CWE 2210373.03r

Subject: Revised Response to DSD-Geology Review Comments, Project Issues Report 1099348, Proposed Single-Family Residence, APN 346-831-44, Ruelle Nicole, La Jolla, California

References: 1) City of San Diego, DSD Geology Review Comments, Project Issues Report 1099348, dated October 11, 2023.
2) Sebastian Mariscal Studio, Architectural Plans, Hermann House, 2538 Ruelle Nicole, La Jolla, CA 92037, dated August 8, 2023.
3) K&S Engineering, Inc., Conceptual Grading and BMP Plans, Hermann House, Lot 25 Montoro, undated.
4) Christian Wheeler Engineering, Report of Preliminary Geotechnical Investigation, CWE 2210373.02, April 17, 2023.

Geologic Cross Section B-B'

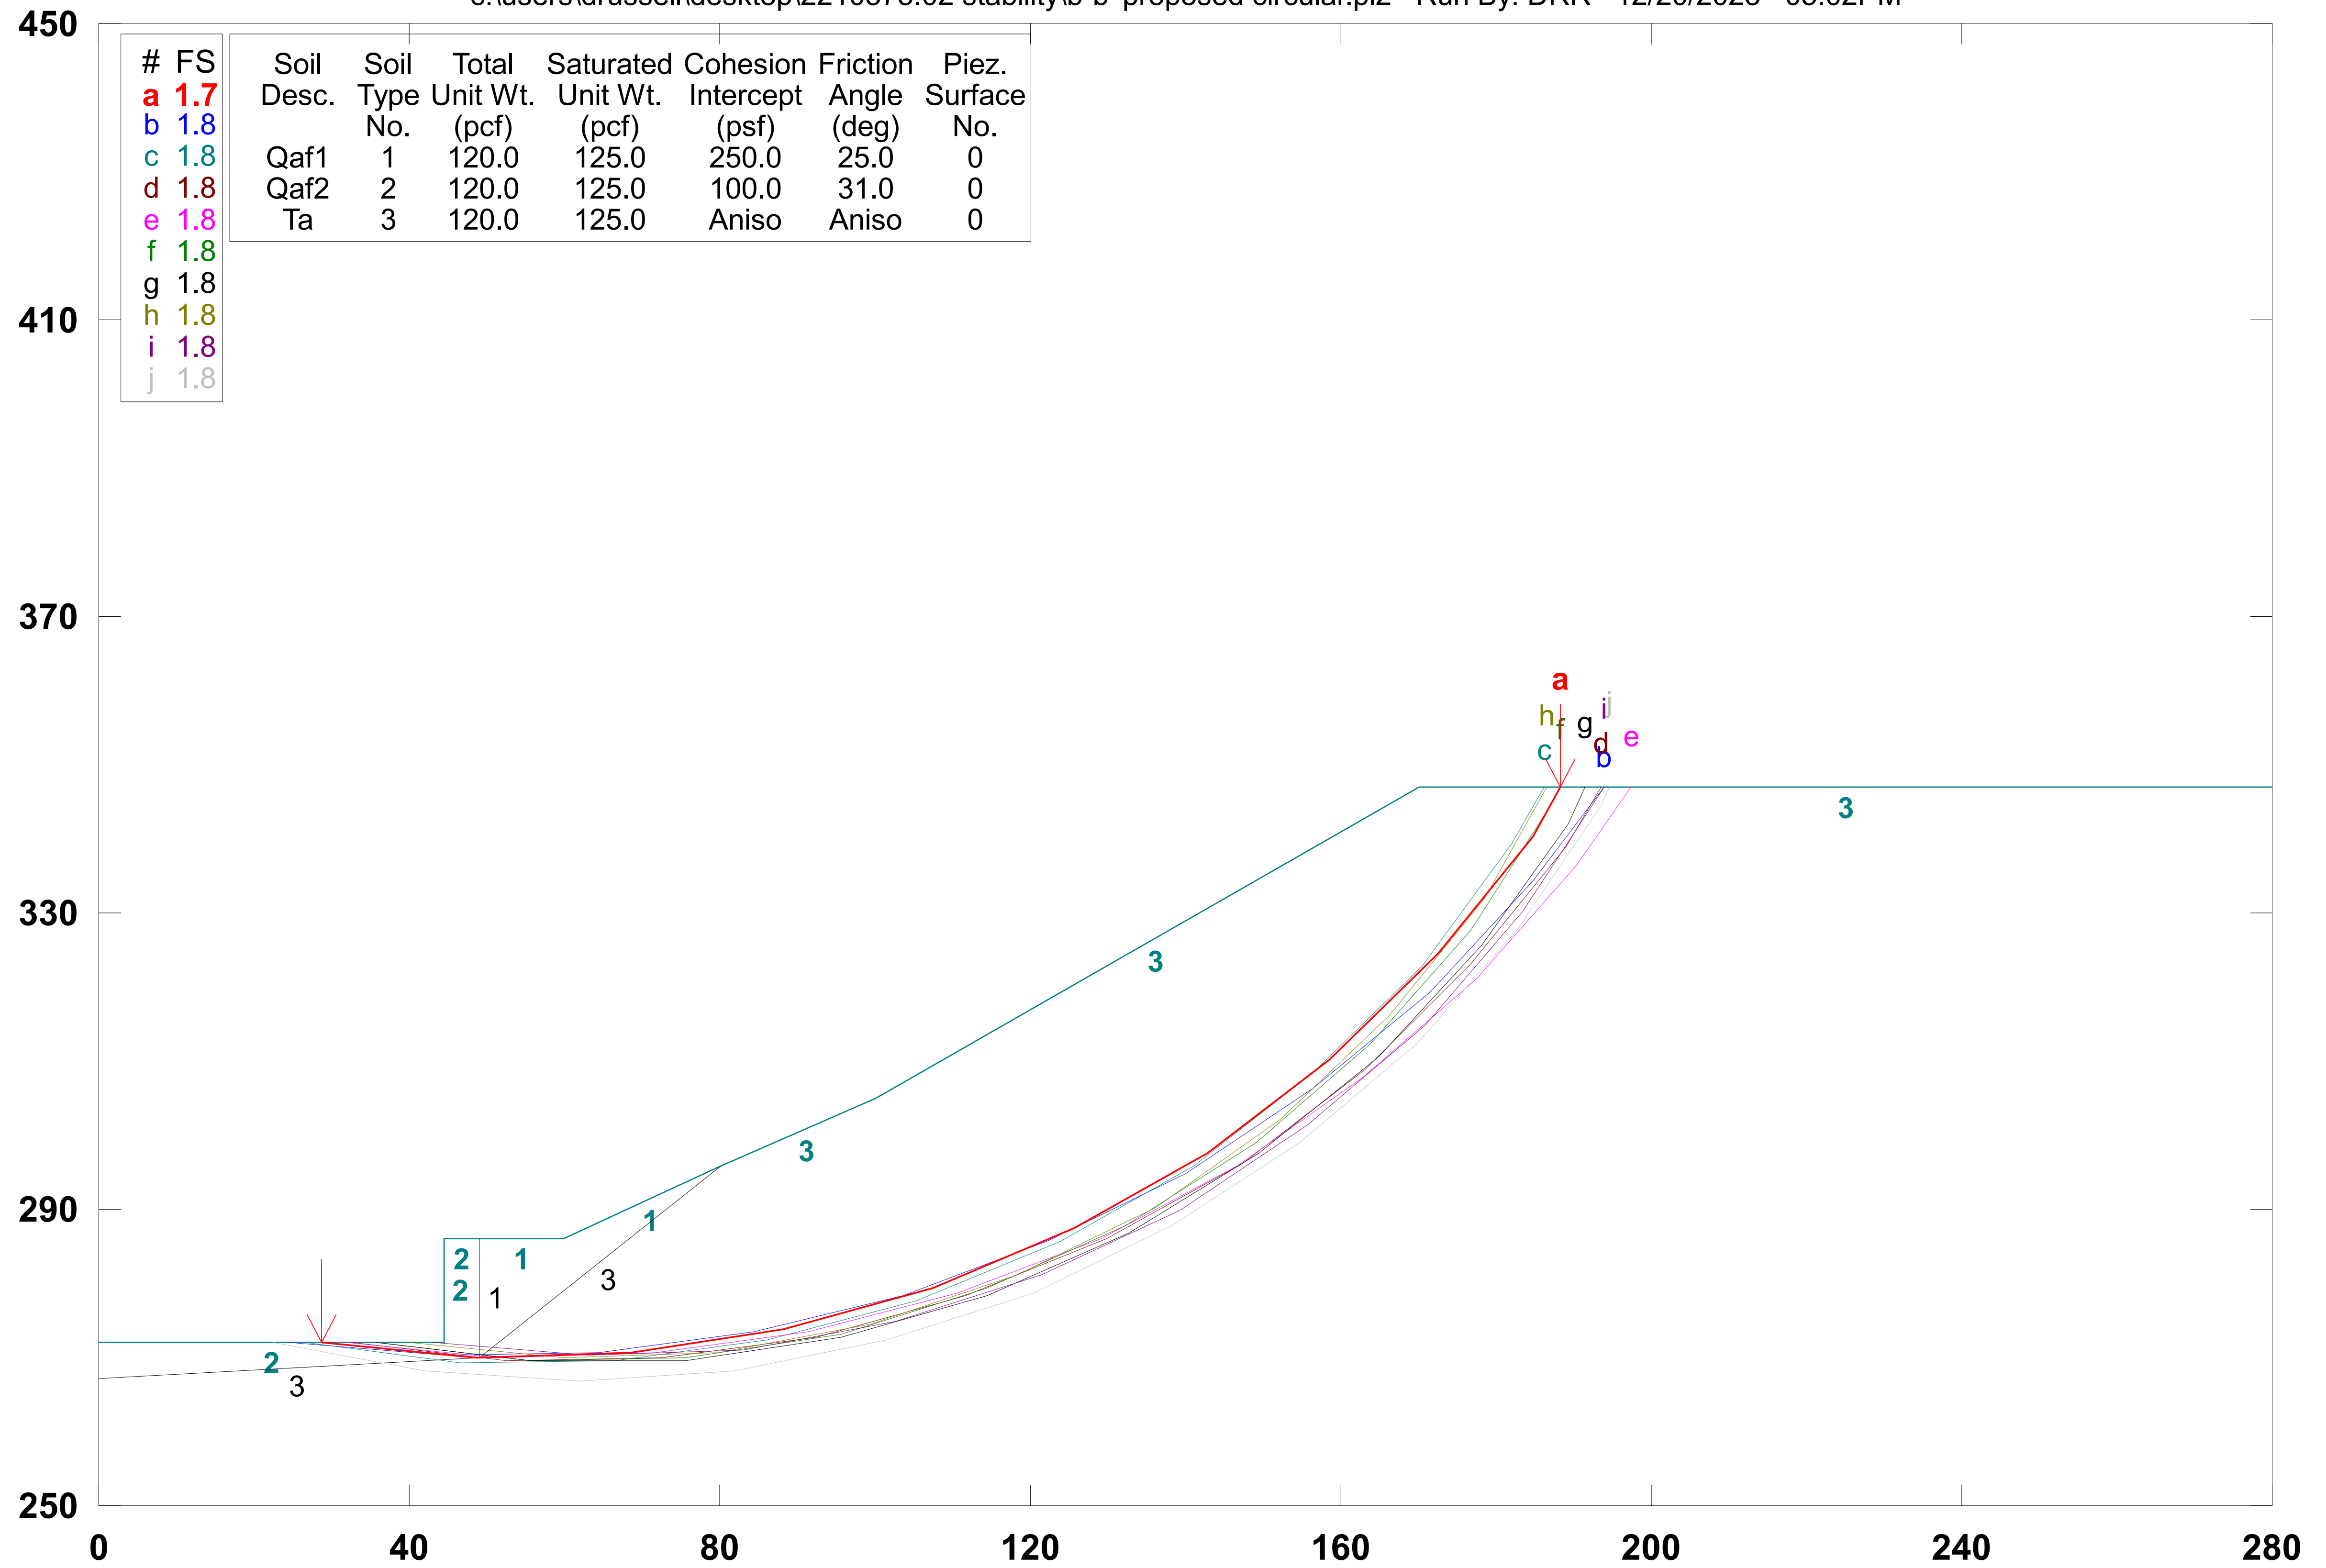
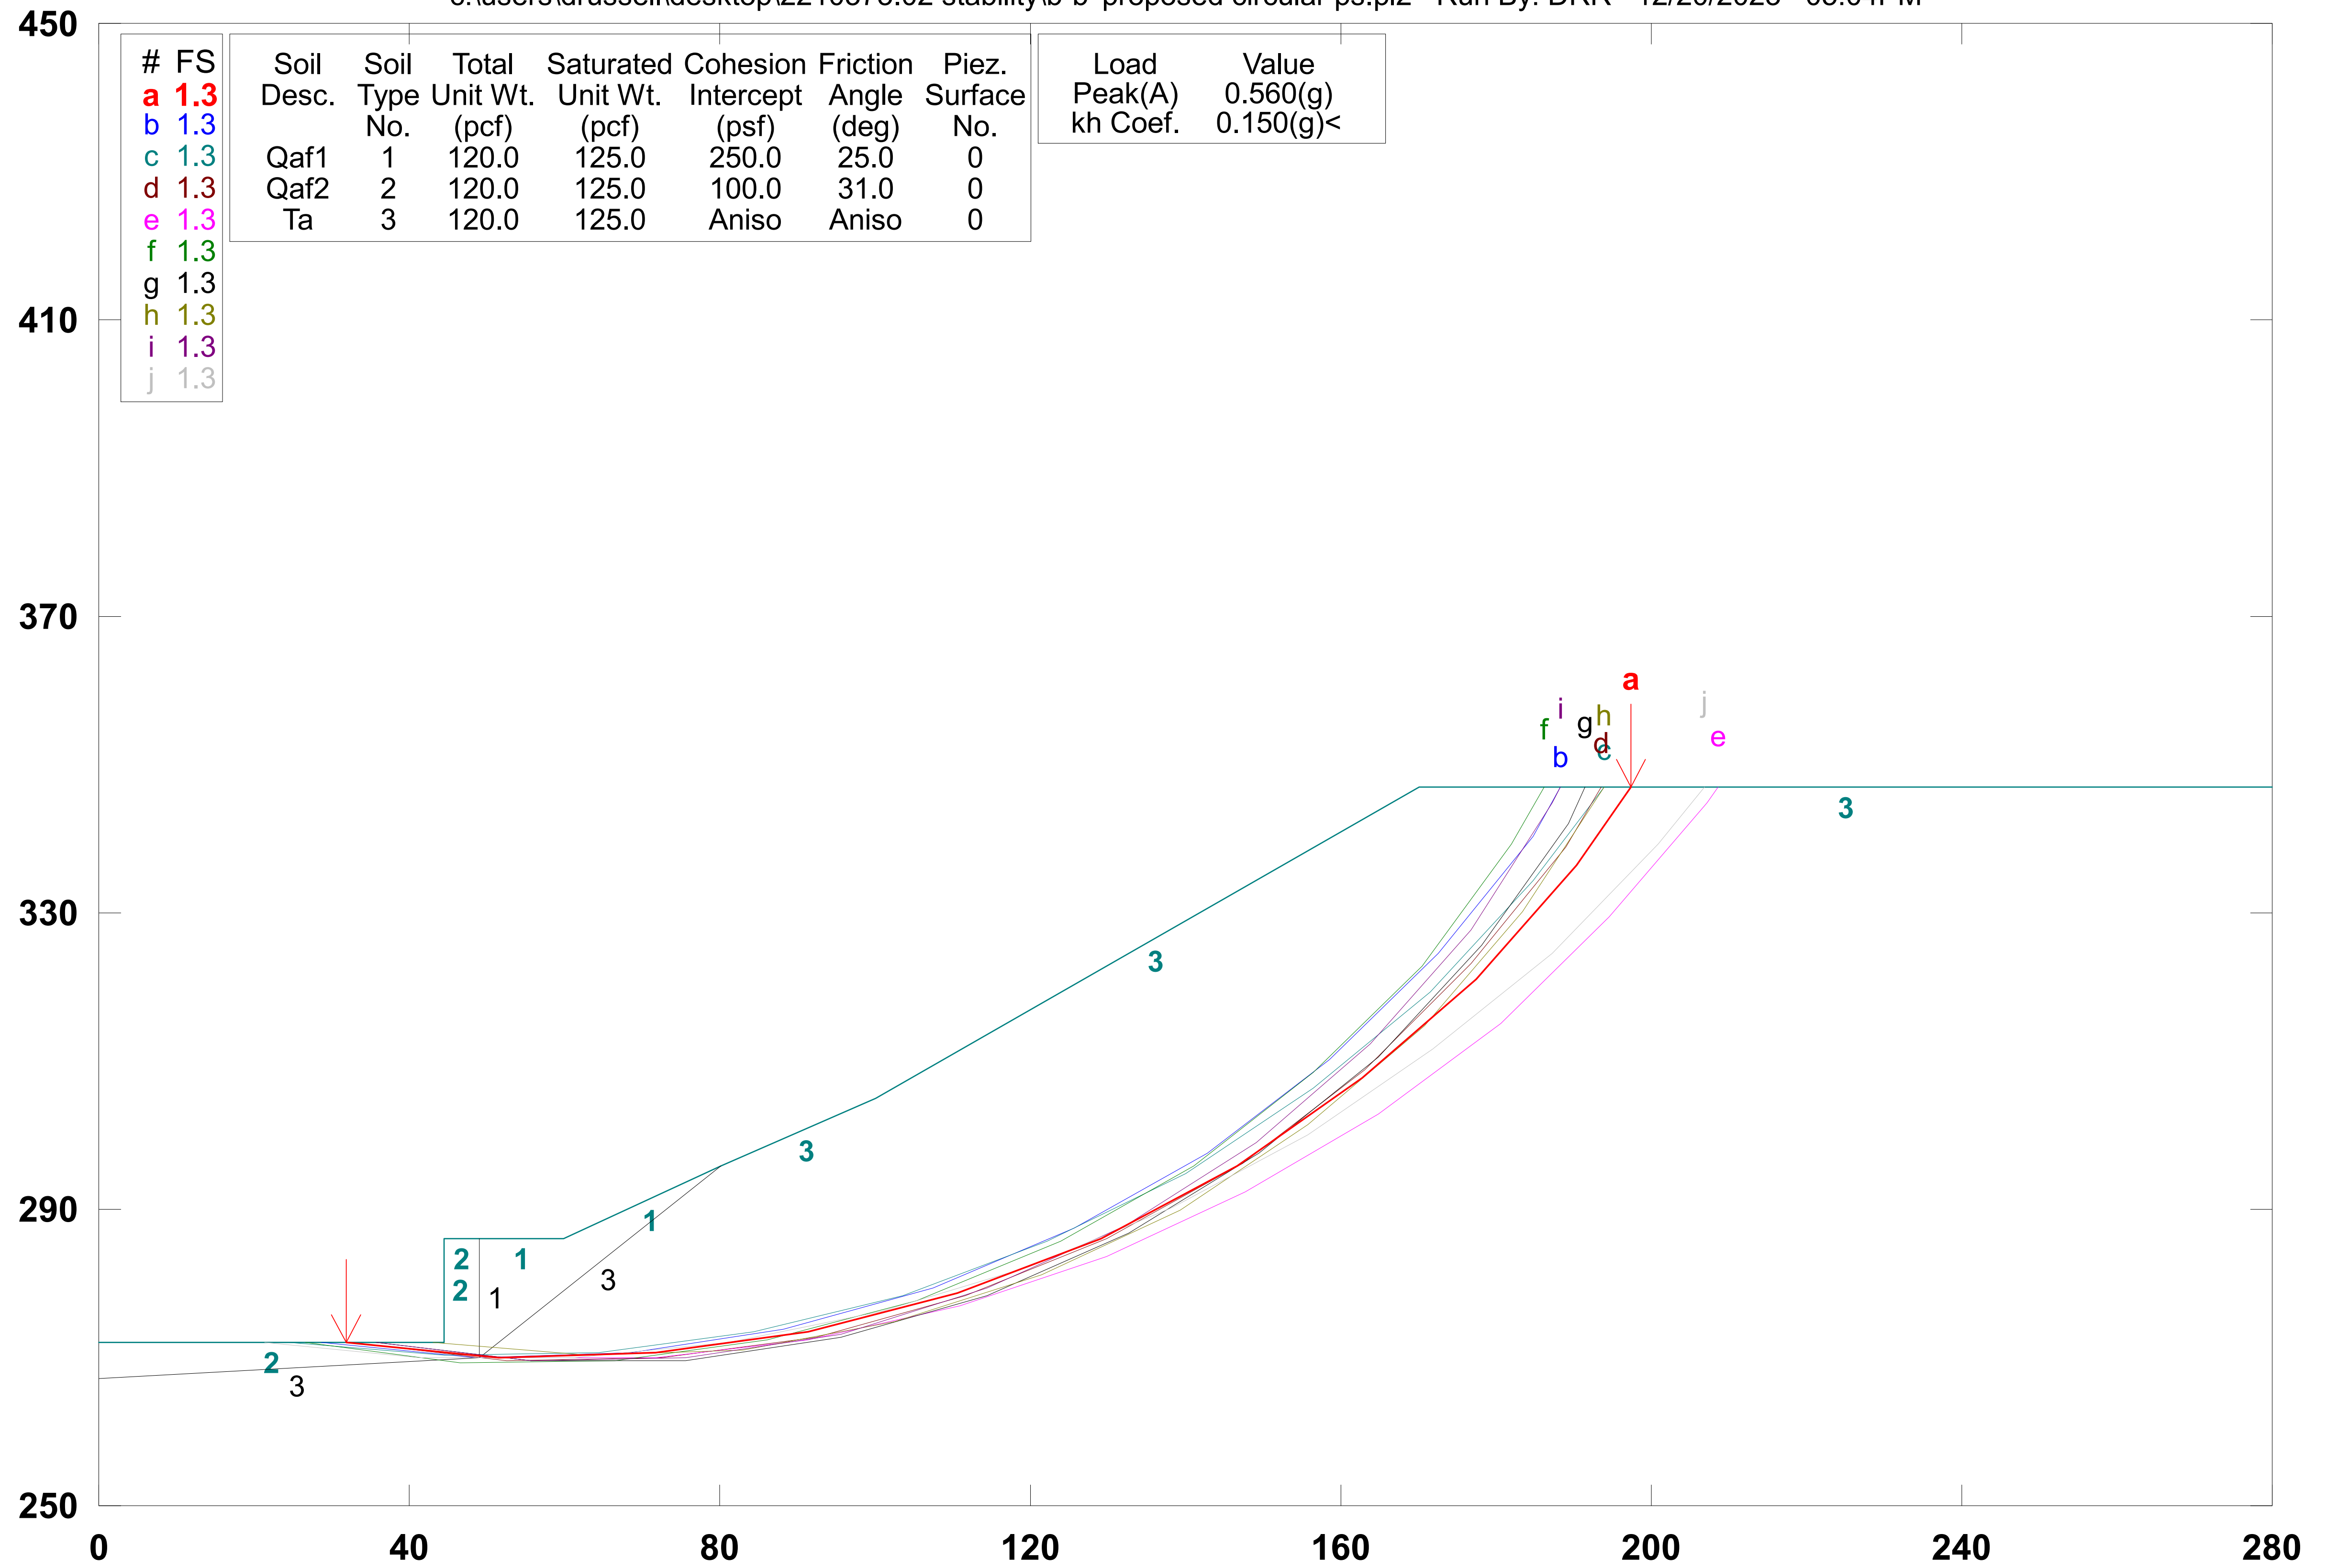
City Comment 00021: Consider providing slope stability analysis of the eastern slope. Where direct observation geologic is not possible utilize conservative shear strength parameters and geologic conditions. Additional analysis and updated geologic cross-sections may be necessary.

CWE Response: Appendix A of this report presents the results of our stability analyses of the existing slope to the east of the proposed residence. The results of these analyses, which were performed using the same parameters included in the analyses presented in our referenced geotechnical report, indicate that the existing slope to the east of the proposed residence (see Plate No. 3 of this report) will demonstrate minimum factors-of-safety against static and pseudo-static failure of 1.7 and 1.3, respectively. These values are in excess of the minimums that are generally considered to be stable of 1.5 and 1.1 for static and pseudo-static analyses, respectively.
